STATE OF NORTH CAROLINA
DEPARTMENT OF TRANSPORTATION

Subject: Request for modification to permanently fill stream adjacent to Lake Brandt in Guilford County on TIP Number R-2413C, Federal Aid Project No. STPNHF-NHF-124-1(1) State Project No. 6499008T, WBS No. 34429.1.1 Division Seven USACE Action ID No. SAW 2002-20447

SITE 3

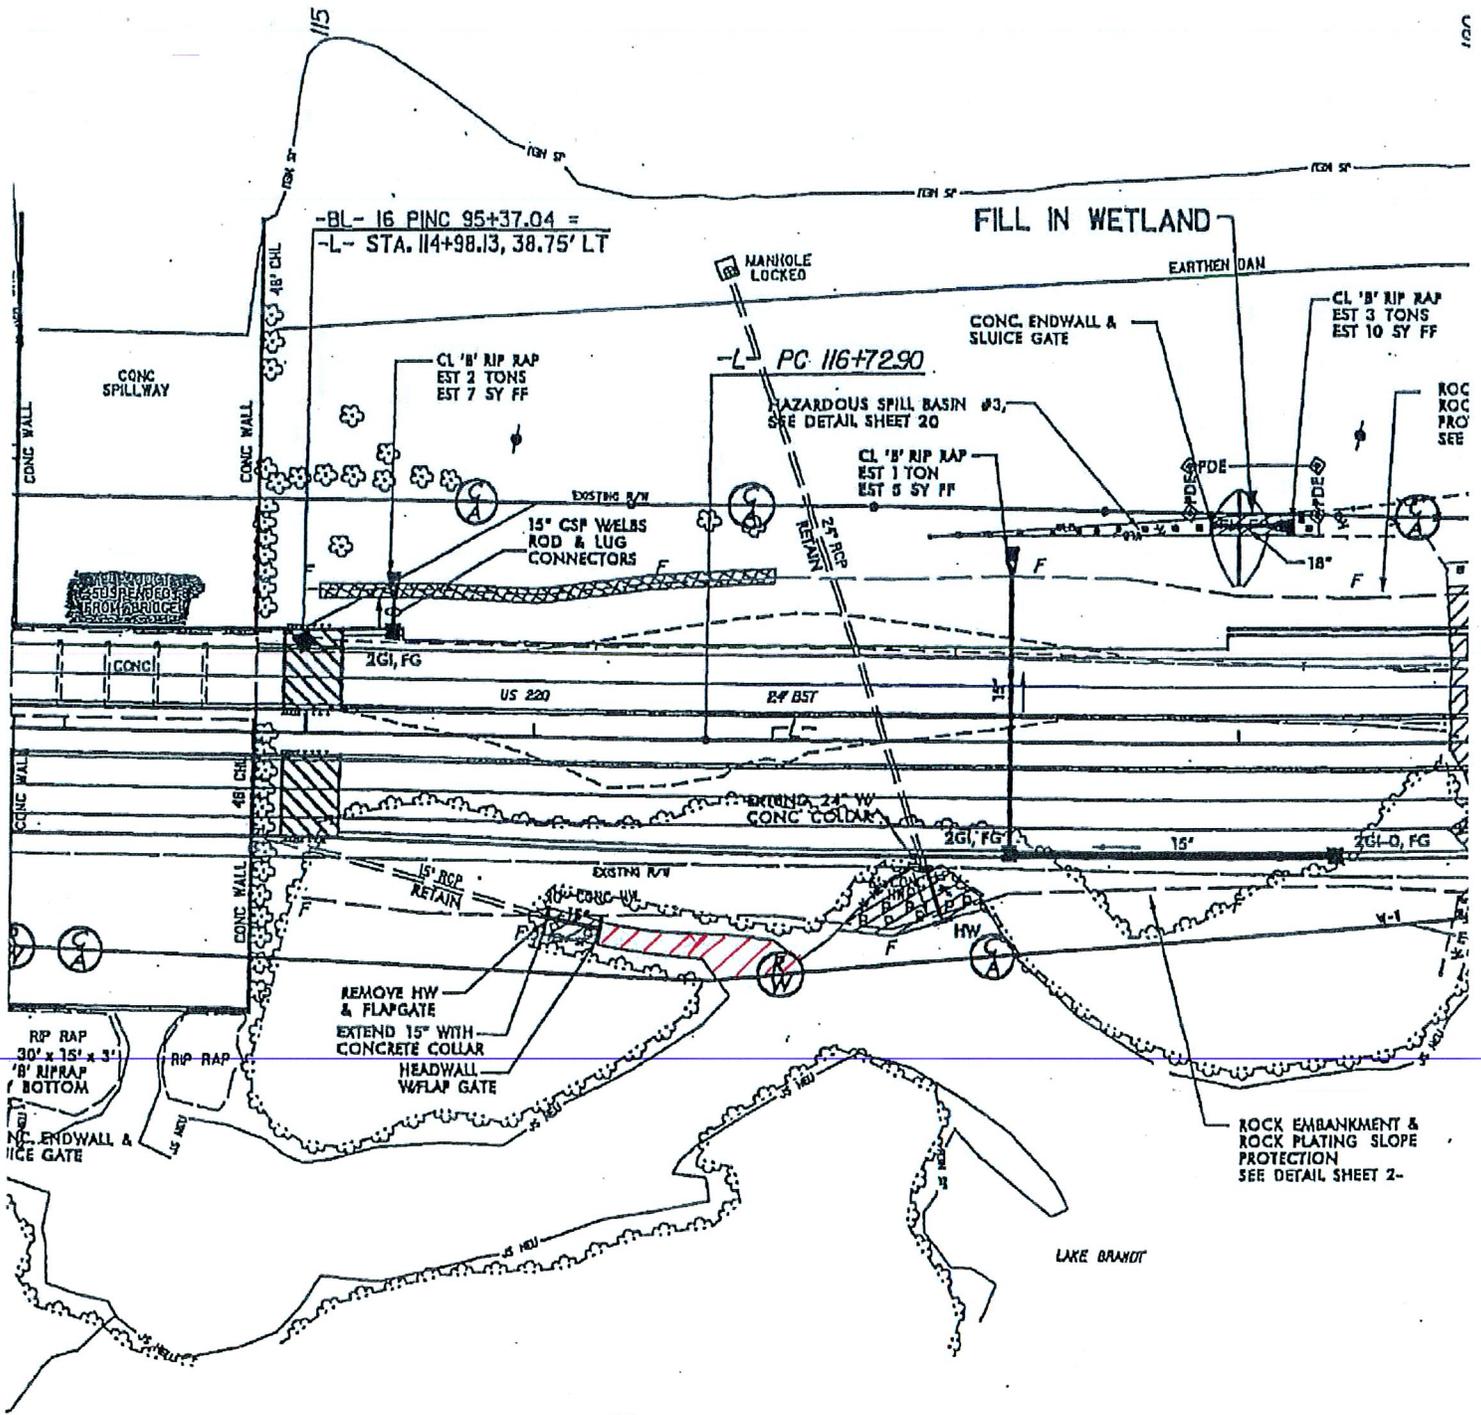
The North Carolina Department of Transportation (NCDOT) is proposing to widen US 220 in Guilford County along the crossing of Lake Brandt and Lake Higgins. In order to extend the fill slope to the necessary limits shown on the permitted plans, a small, short stream adjacent to Lake Brandt will be filled. Permitted plans do not account for impacts to the stream although they show the right-of-way extending beyond the stream. The impacts are necessary in order to construct the road to NCDOT standards. The elevated bridge approach across the nearby spillway has resulted in the need for extended fill slope. The proposed area is located near Site 3 which is just north of the spillway on US 220 on Plan Sheet 11.

The construction of the fill slope will result in 902 square feet (0.02ac) of permanent open water impacts to a tributary of Lake Brandt. NCDOT no longer proposes to replace the headwall and flapgate, nor extend the 15 inch culvert that empties into Lake Brandt that are shown on the plans. Impacts within the buffer have already been accounted for in the original permit. No wetland impacts are anticipated during construction.

Added Area = 902 FT²
